Access Compliance Report

Public Rights-of-Way

(Curb Ramps)

Intersection ID: 1003389	Main Street: DAVIS_CROSSING_CT	Cross Street: N/A	Location: W
ADA ID: 638301695973	Ramp Type: Perp	Initial Pass/Fail: Fail	Overall Compliance: No
Severity Score: 8.75			
Codes/Mitigation Info/Possible Solution		Field Measurements/Component Compliance

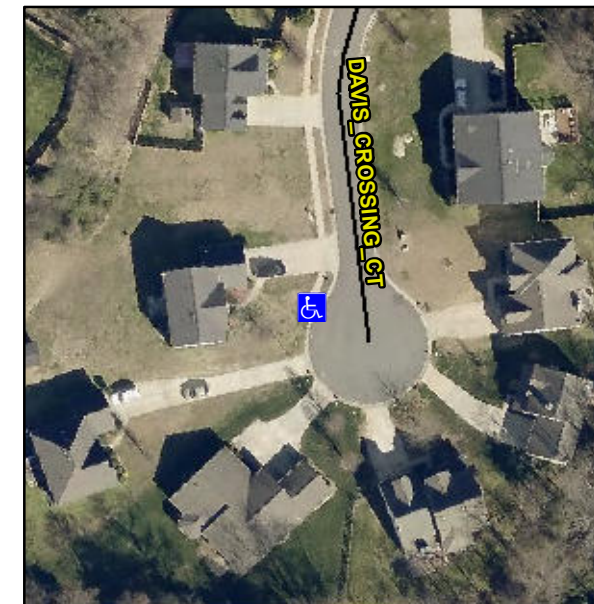
R304.5.1

Compliance	Description	Data	Compliance	Description	Data
N/A	Ramp Length (in)	36.0	Yes	Ramp Slope (%)	6.2
No	Ramp Width (in)	47.5	Yes	Ramp XSlope (%)	1.2
N/A	Flare Type LT	N/A	N/A	Flare Type RT	N/A
N/A	Flare Slope LT (%)	N/A	N/A	Flare Slope RT (%)	N/A
N/A	Flare Traversable LT?	N/A	N/A	Flare Traversable RT?	N/A
N/A	Landing Length (in)	N/A	N/A	DWS Provided?	N/A
N/A	Landing Width (in)	N/A	N/A	DWS Contrast?	N/A
N/A	Landing Slope (%)	N/A	N/A	DWS Length (in)	N/A
N/A	Landing X Slope (%)	N/A	N/A	DWS Full Width?	N/A
N/A	Landing Curb? (Y/N)	N/A	N/A	DWS Offset (in)	N/A
N/A	Shared Landing?	N/A			
N/A	Gutter Ponding?	N/A	N/A	Gutter Slope (%)	N/A
N/A	Gutter Lip Ht (in)	N/A	N/A	Gutter X Slope (%)	N/A
N/A	Painted X Walk1?	No	N/A	Painted X Walk2?	N/A
	X Walk 1 Direction	To SE		X Walk 2 Direction	N/A
N/A	X Walk 1 Width (in)	N/A	N/A	X Walk 2 Width (in)	N/A
	X Walk 1 Slope (%)	0.4		X Walk 2 Slope (%)	N/A
	X Walk 1 X Slope (%)	2.9		X Walk 2 X Slope (%)	N/A

Remove & Replace Entire Ramp.
